# RENESAS TECHNICAL UPDATE

Product Category	MPU/MCU		Document No.	TN-RX*-A003A/E	Rev.	1.00
Title	RX610 Group Notes on DMAC/DTC transfer using Communication Function		Information Category	Technical Notification		
Applicable Product	RX610 Group	Lot No.	Reference Document	RX610 Group Hardware Manual		
		All lots

## 1. Notes on transferring DMAC/DTC using Communication Function (SCI, RIIC)

Example) SCI reception + DTC transfer (CPU interrupt (DISEL = 1) for every transfer), a DMAC block transfer using the IRQ interrupt

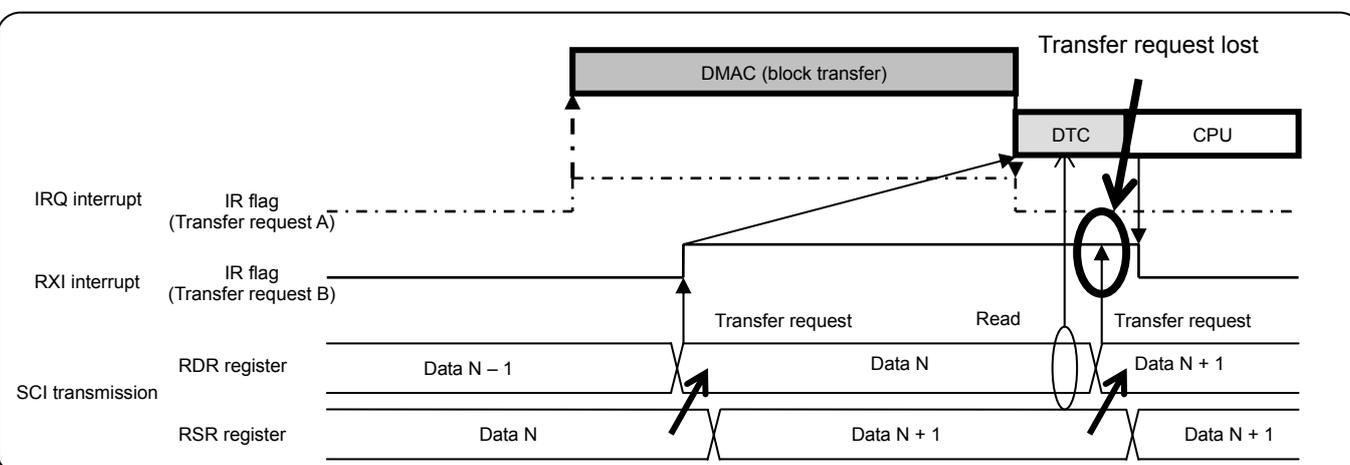
When the DMAC/DTC is activated using an interrupt from the communication function, the DMAC/DTC cannot accept an activation request from the communication function and may not perform DMAC/DTC transfer. In this phenomenon, when the next transfer request is issued by the time that the interrupt status flag (IR flag) is automatically cleared after data transfer (reading reception data or writing Transmit data) using the DMAC/DTC, the transfer request is lost.

For example, when the DTC is activated using the SCI reception interrupt with CPU interrupt (DISEL=1) for every transfer, the IR flag is set to 1 in a first receiving operation and the DTC is activated. After the DTC transfer, the IR flag is retained at 1 until the CPU interrupt is received. In the meantime, if a second receiving operation is completed, a setting of the IR flag that is the transfer request is ignored. Therefore, the DTC cannot be activated, and the data received in second receiving operation cannot be transferred.

- When the DMAC is used with ISEL[1:0] = 11b, use the DTC with DISEL = 1 and implement the following preventive measures.
- When the DTC is used with DISEL = 1, it should be used such that the transfer request is not lost, or implement the software preventive measures of the DTC to prevent the transfer request from being lost.

The flowchart for measures with DISEL=1

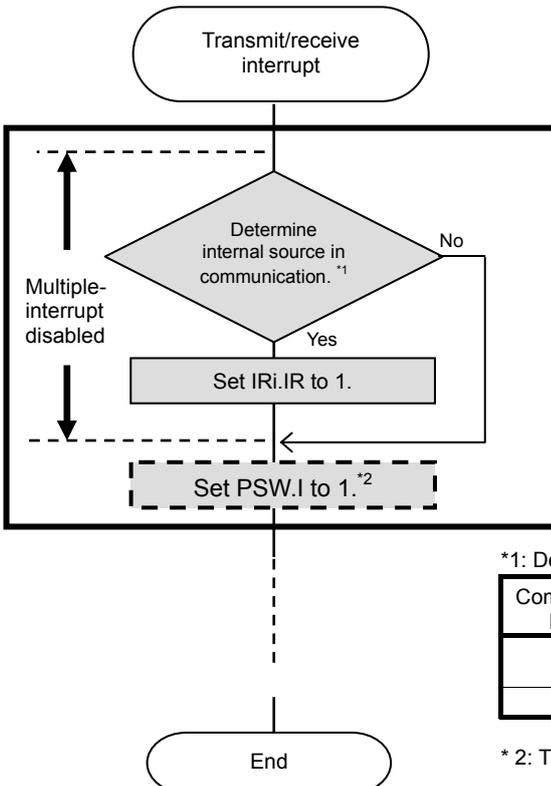
The flowchart for software preventive measures to be taken for the DTC is shown below. \*

Addition (Software preventive measures)

\*1: Determination of Internal Source in Communication

\* 2: This step is not required when multiple-interrupt is not used.
